Addendum #04

ADMINISTRATION BUILDING ROOF AND SIDEWALK REPLACEMENT
Salem State University – North Campus
Salem, MA

MASS. STATE PROJECT NO. SSU-2021-A Contract #1
CAMIS NO. J226800
JONES ARCHITECTURE PROJECT NO. 2011

August 31, 2020

SKA-001

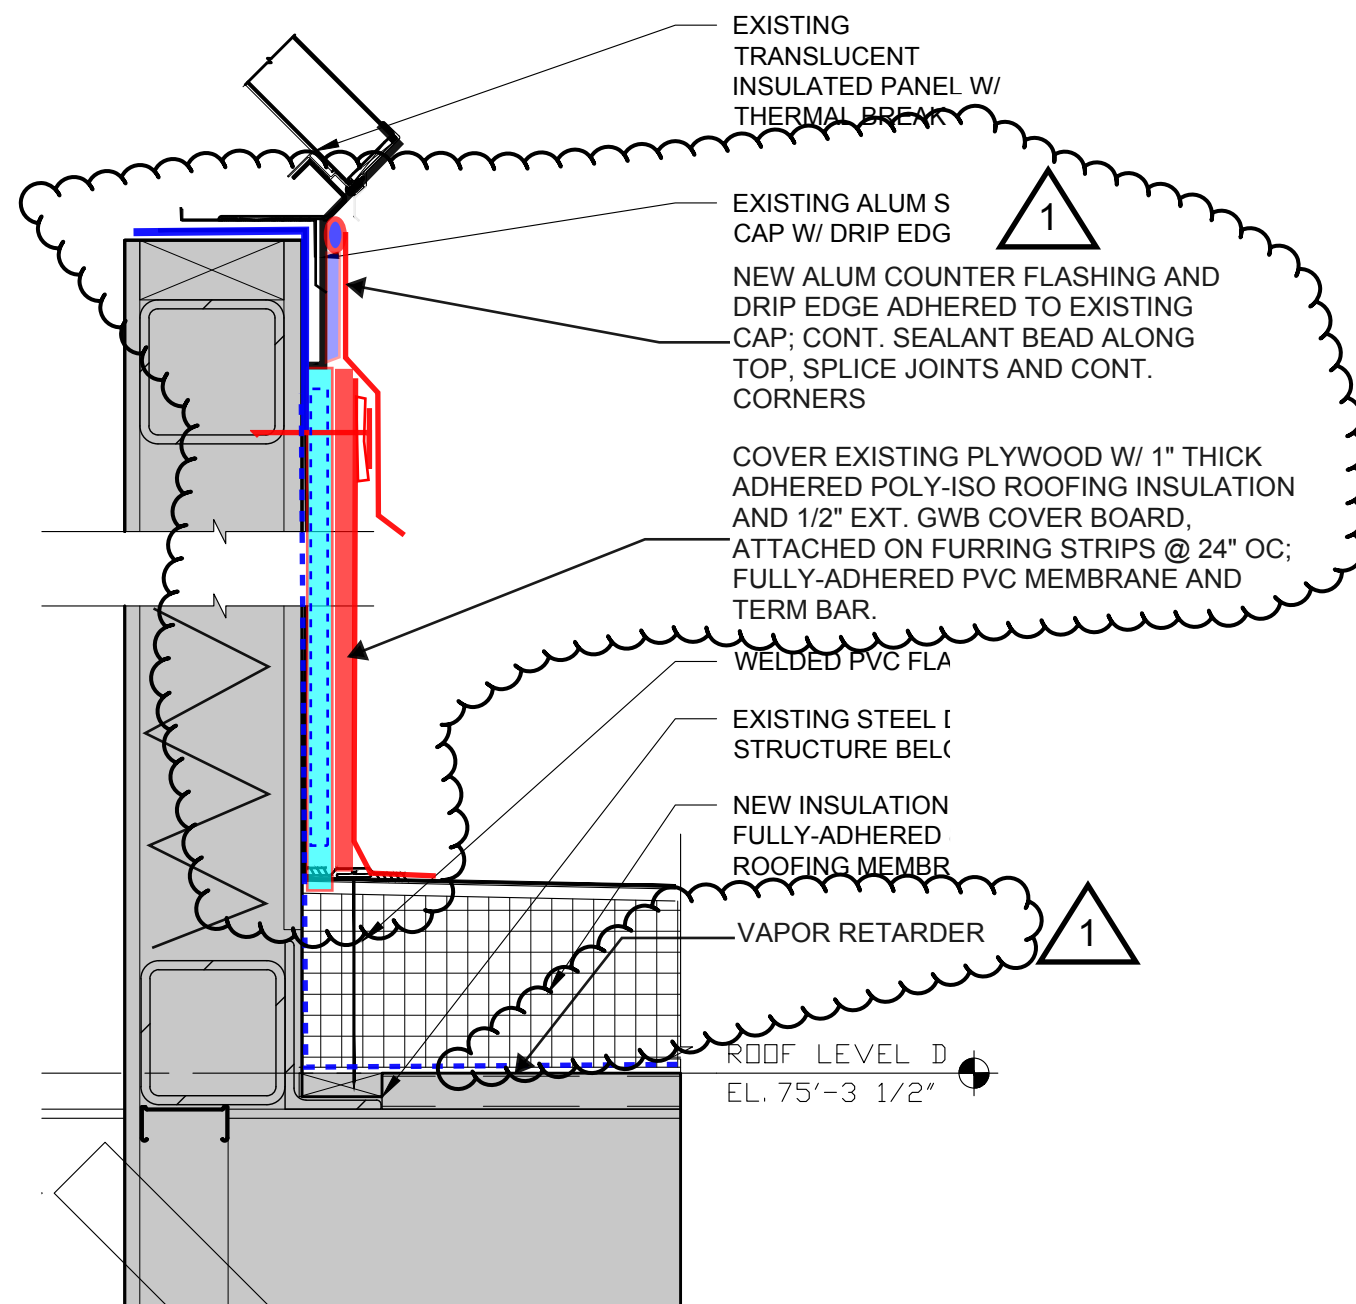
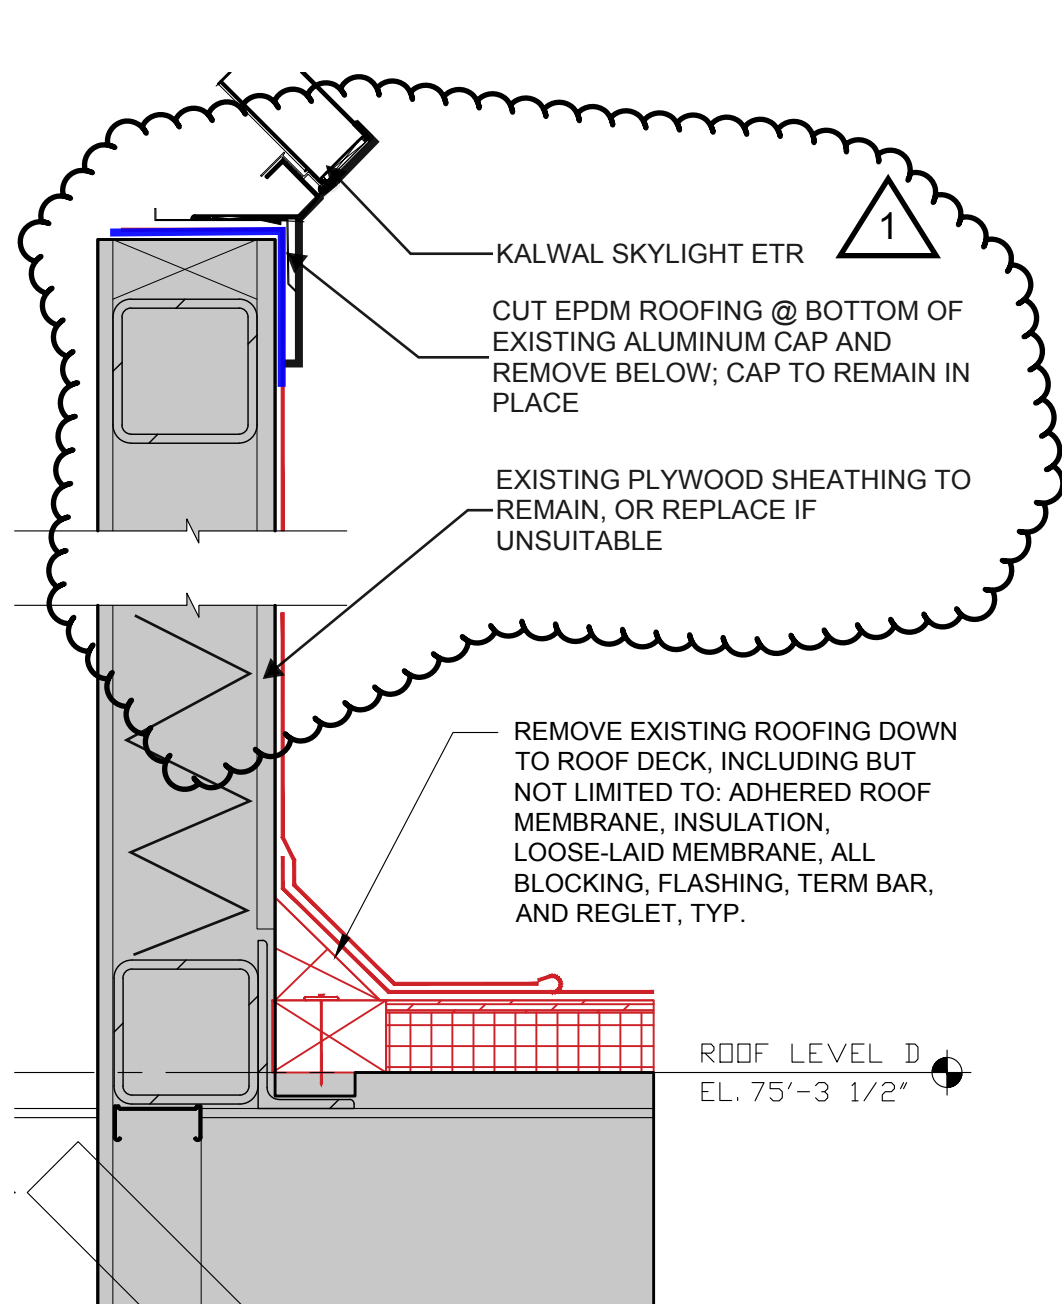
12. Q. DOES THE ROOFING SUB OWN NON-PENETRATION ROOF RAILS?
A. Yes.
13. Q. SPECS SAY VAPOR BARRIER 40 MIL BUT PLANS SAY 31 MIL?
A. 40 Mil is correct.
14. Q. DOES THE WATERPROOFING SUB OWN THRU METAL FLASHING ON DRAWING 2A-513?

A. Drawing 2A/513 does not exist. If this question refers to the T-ZCC counterflashing along the length of the sidewalk shown in Detail 2, then this flashing shall be furnished and installed by Masonry subcontractor. New sealant by waterproofing subcontractor. Coordinate sealant with all new weep tubes with Mason.

- NOTES:
1. REMOVAL OF SEALANT BY GC. ASSUME ACM - TO BE CONFIRMED BY OWNER
 2. NEW FLASHING AND WEEP TUBES BY MASONRY SUBCONTRACTOR
 3. NEW SEALANT BY WATERPROOFING SUBCONTRACTOR - COORDINATE WORK WITH MASONRY WEEP TUBES.

SKA-003

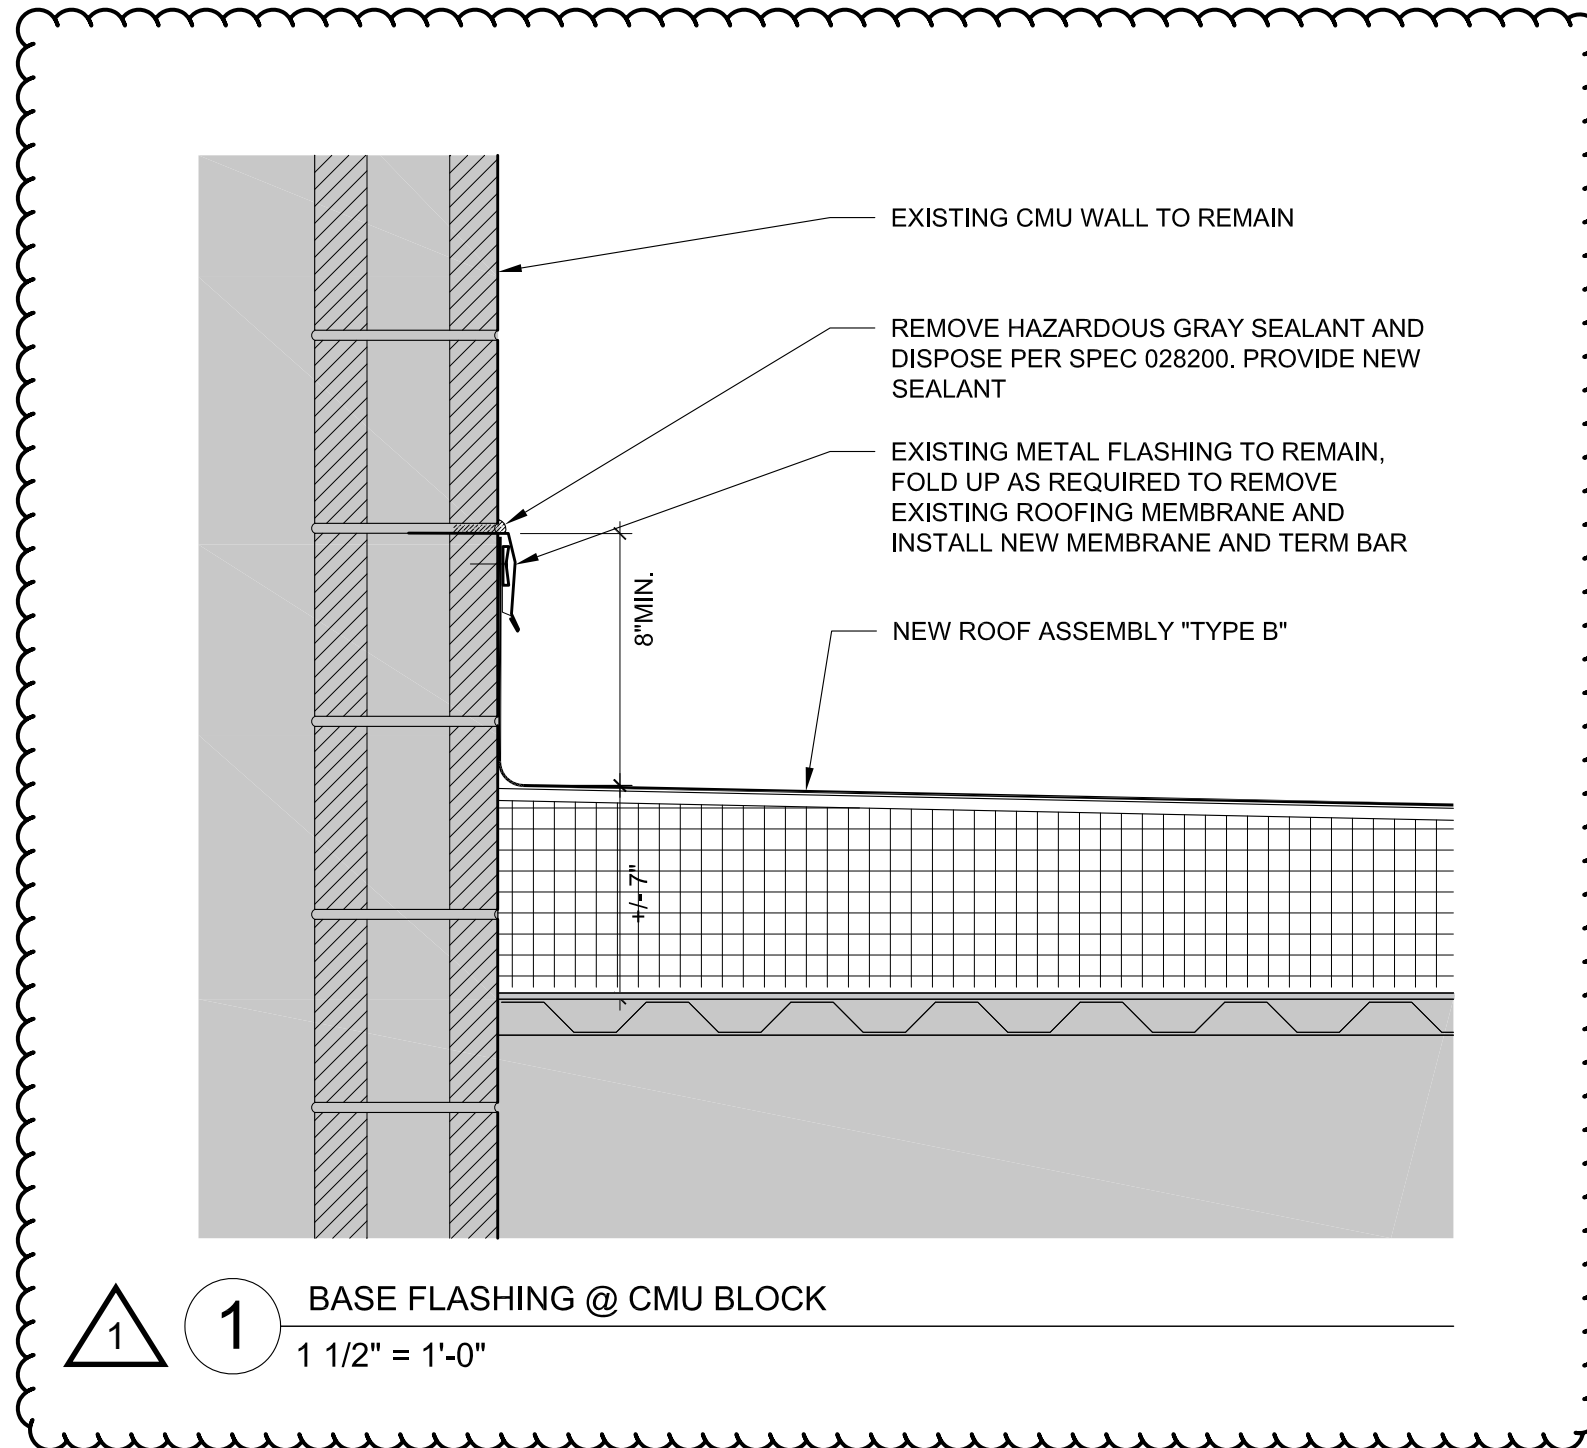
- Pre-Bid Conference Attendance Sheet
- Revised Drawings
 - *SKA-001 – Sidewalk Flashing Detail*
 - *SKA-002 – Skylight Curb Details*
- New Drawings
 - *SKA-003 – Base Flashing Detail at Block Wall*

1 BASE FLASHING @ CMU BLOCK
 1 1/2" = 1'-0"
